**Total Maximum Daily Loads
of Nutrients and Dissolved Oxygen
Under Low-Flow Conditions
In the Christina River Basin,
Pennsylvania, Delaware and Maryland**

United States Environmental Protection Agency
Region III

January 19, 2001
(revised October 2002)
(revised April 2006)

Christina Comments and Responses

Figure 6. Modeled stream segments violating daily average dissolved oxygen water quality criteria based on the EFDC model using 1997 calibration data.

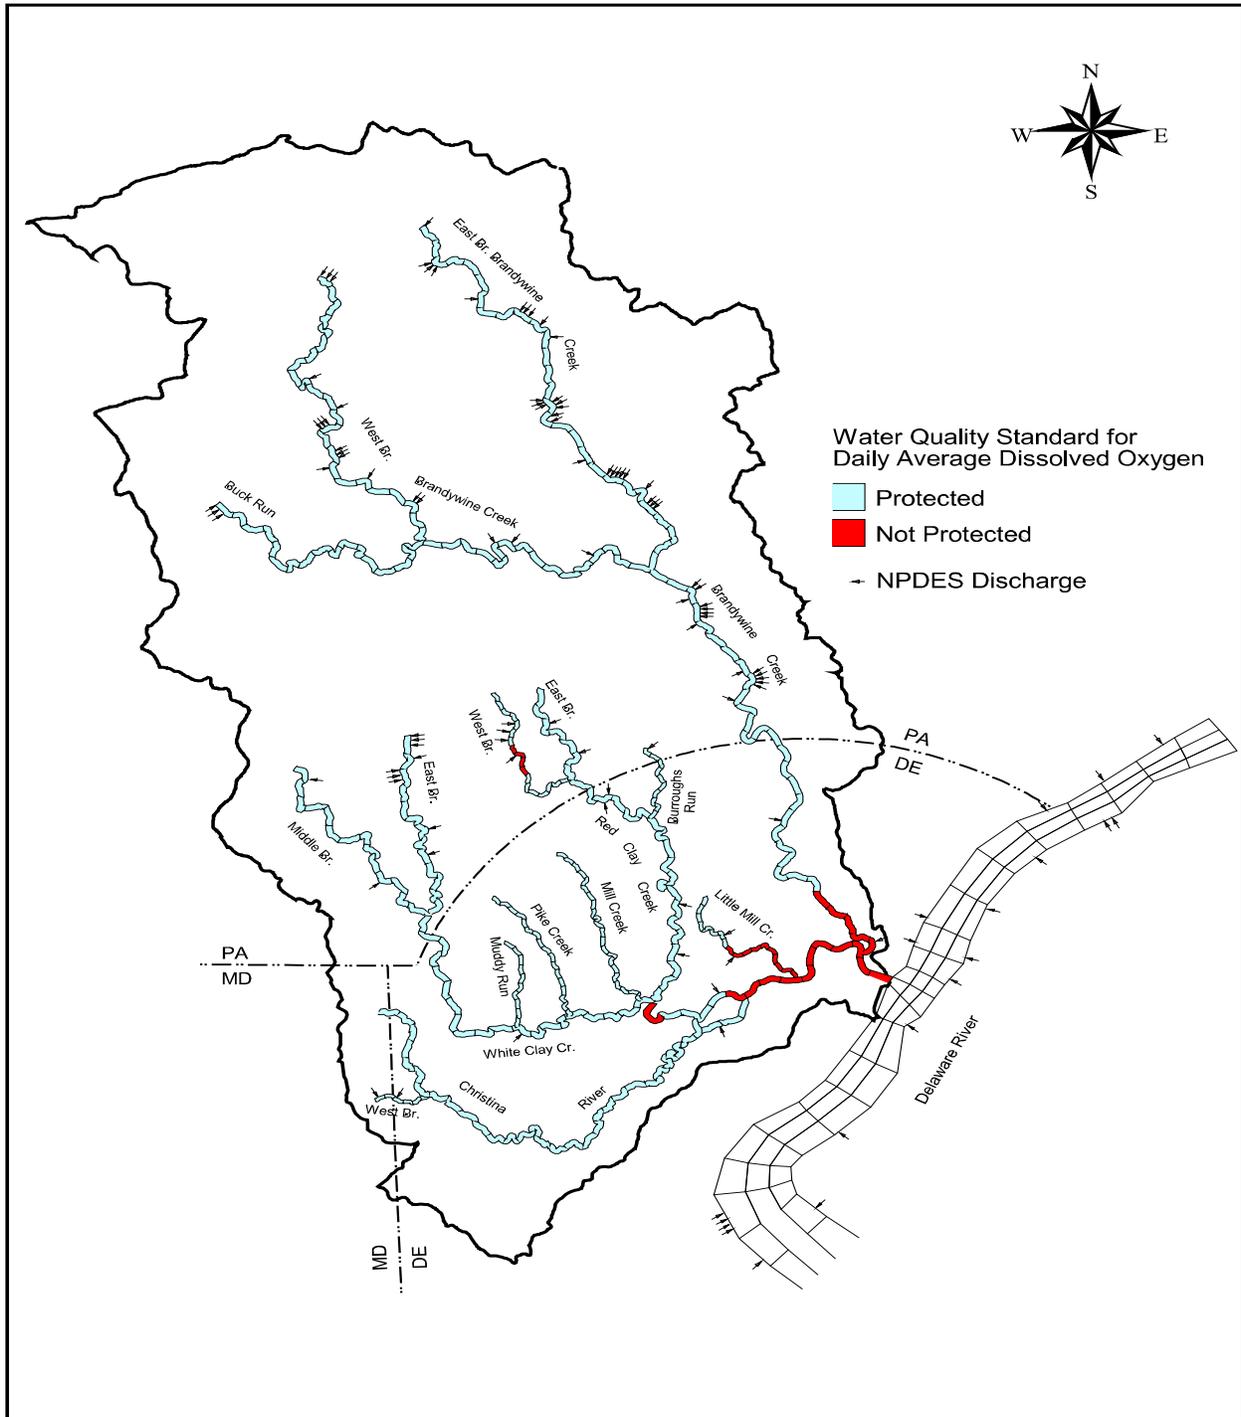
In Figures 6 and 7, TMDL model results are presented showing the locations where water quality standards for daily average DO and minimum DO are not protected during the August 1997 calibration period. The TMDL model indicates the daily average DO in a portion of the tidal Christina River does not meet the water quality criteria of 5.5 mg/L. A smaller portion of the Christina River does not meet water quality standards under the critical conditions TMDL model run (Figure 8). This is somewhat misleading because a point source in Little Mill Creek was active for the 1997 calibration period, but is no longer active today and was not included in the critical conditions model run (Figure 8). The loads from that point source were influencing the tidal Christina River in the vicinity of the mouth of Little Mill Creek during the calibration runs but not during the critical conditions run.

Figure 8. Modeled stream segments violating daily average dissolved oxygen water quality criteria based on the EFDC model during critical conditions.

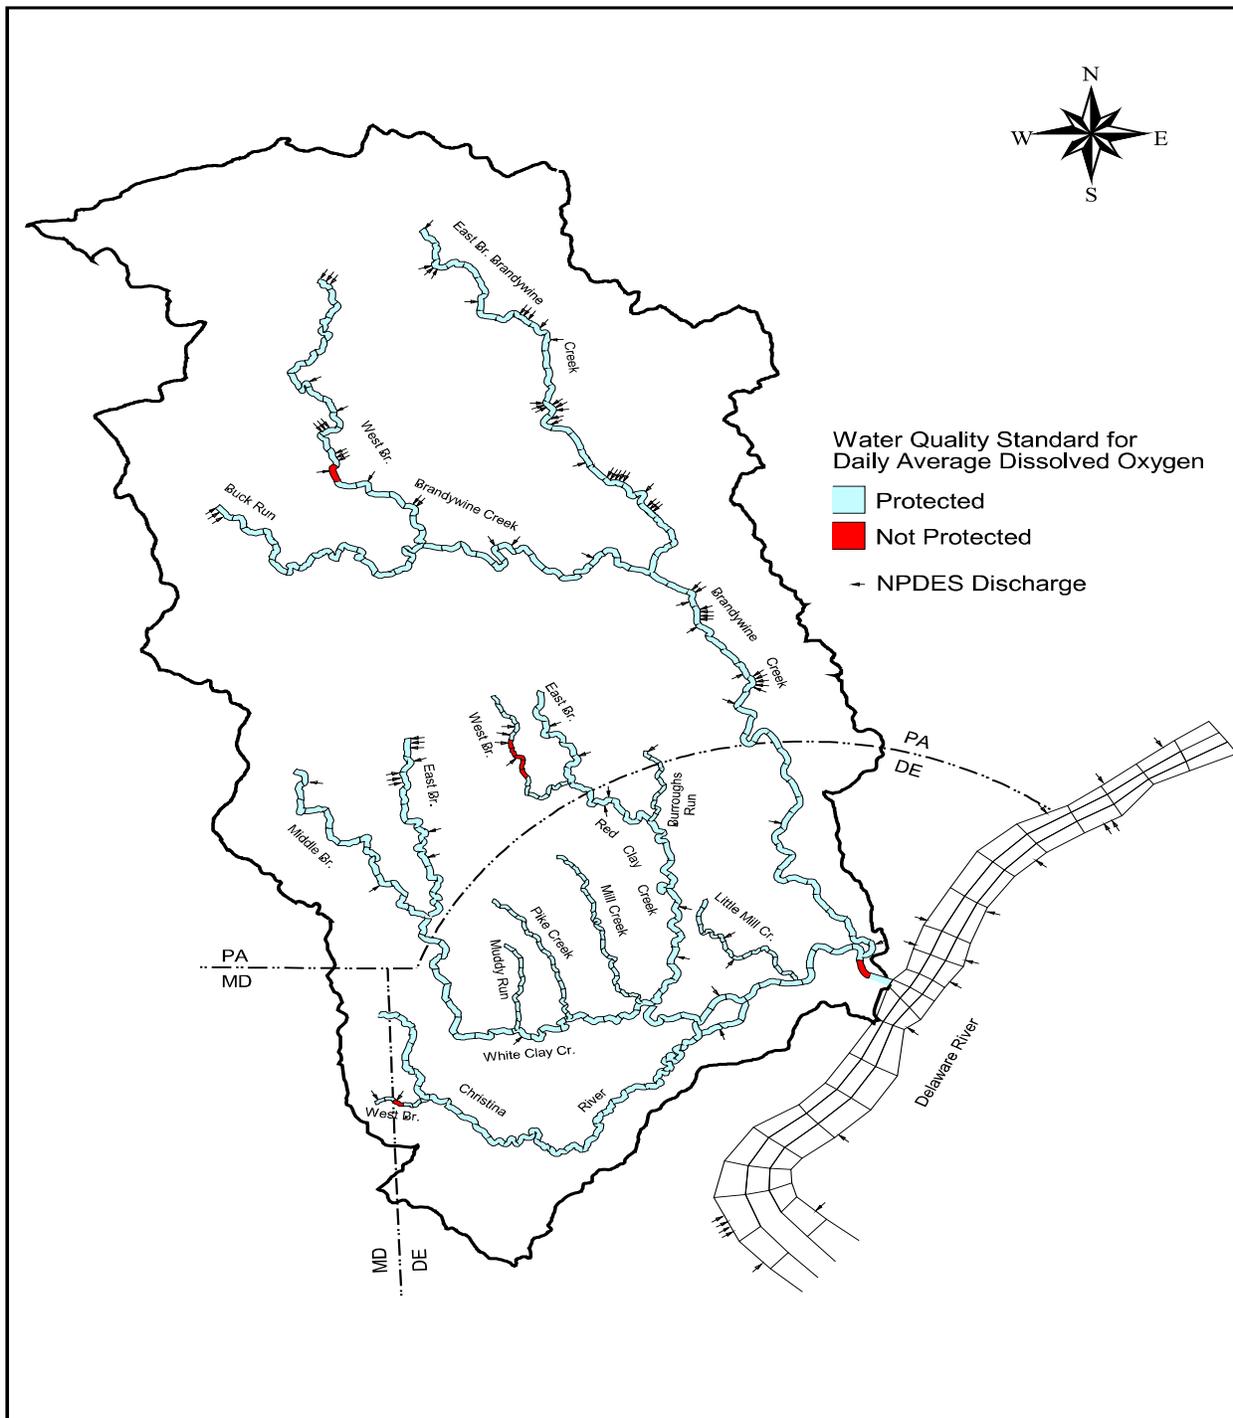
Refer to Figure 8 and Figure 9 in the TMDL Decision Rationale document. These figures present model results indicating the locations where the water quality standards for daily average DO (Figure 8) and the minimum DO (Figure 9) are not protected during critical summer low-flow conditions with NPDES sources discharging at their existing monthly average permit limits. These two figures indicate that a large portion of the East Branch Brandywine Creek are indeed adversely affected by nutrient loads under assumed critical conditions.

Figure A-3. Brandywine Creek East Branch, daily average DO.

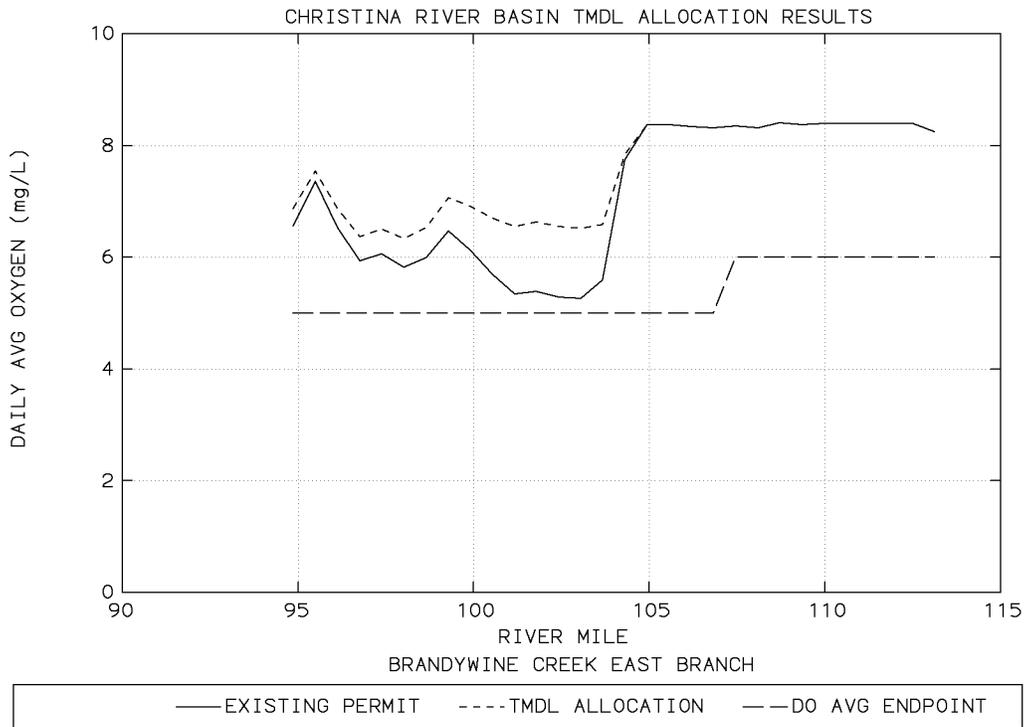
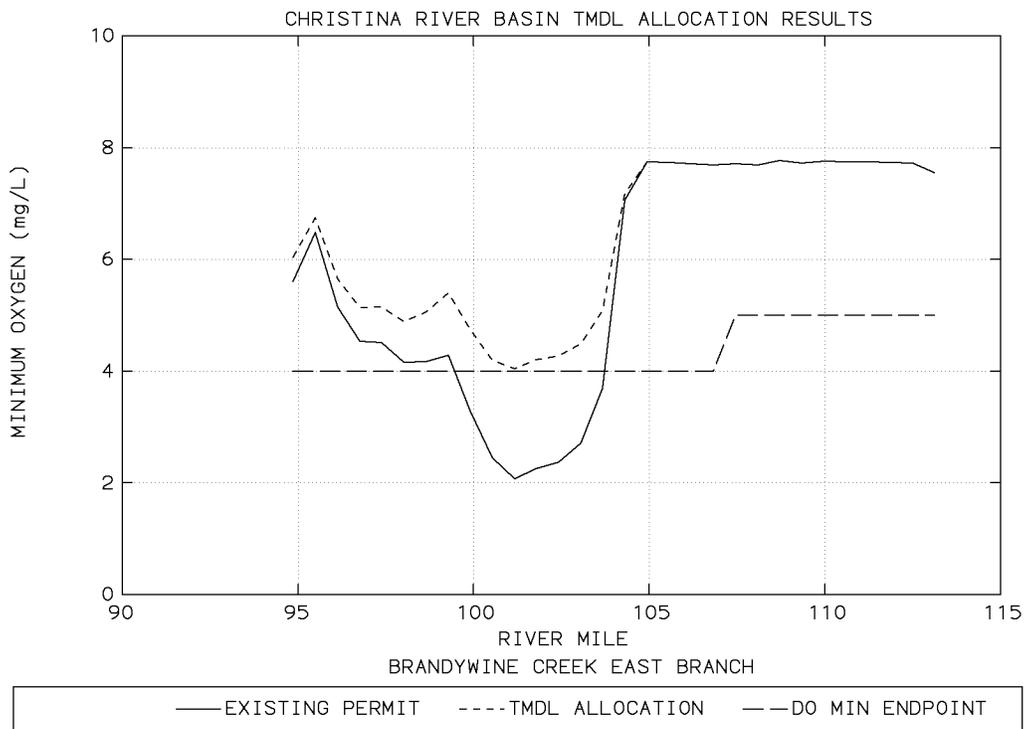
01-A-05	Predictions made by the low-flow model for the East Branch Brandywine Creek as shown in Appendix H greatly under estimate the dissolved oxygen levels of the receiving stream and over estimate the pollutant loadings to the receiving stream when compared to actual observed levels (Figs. H07-H08). Its ability to predict the impacts of the point source discharges during critical conditions is therefore questionable and needs further review.	Herbert J. May	EPA disagrees. The Figures in Appendix H of the Hydrodynamic and Water Quality Model of Christina River Basin, EPA, May 31, 2000 ('Model Report') show the model results under critical conditions with the NPDES facilities discharging at their existing permitted flows and loads. These figures are not the calibration or validation results. The observed data displayed on these figures are from the period August 1 to September 21, 1997 (the calibration period) and are shown for reference only and are not an indication of model performance.

The change in the value of the phosphorus half-saturation constant from 0.132 mg/L to 0.005 mg/L only affected East Branch Brandywine Creek. The effect of the change in KHPm on model calibration was subtle. Figures A-3 and A-4 show the revised daily average DO and minimum DO plot along Brandywine Creek East Branch resulting from the change in KHPm. Figure 9-9 in the model report (EPA 2000) showed the calibration of diel dissolved oxygen at three locations: Brandywine Creek at Chadds Ford, East Branch Brandywine Creek downstream of Downingtown, and West Branch Brandywine Creek at Modena. In the revised Figures 9-9 in this addendum, the calibration results look very similar to the original model that used KHPm=0.132 mg/L.
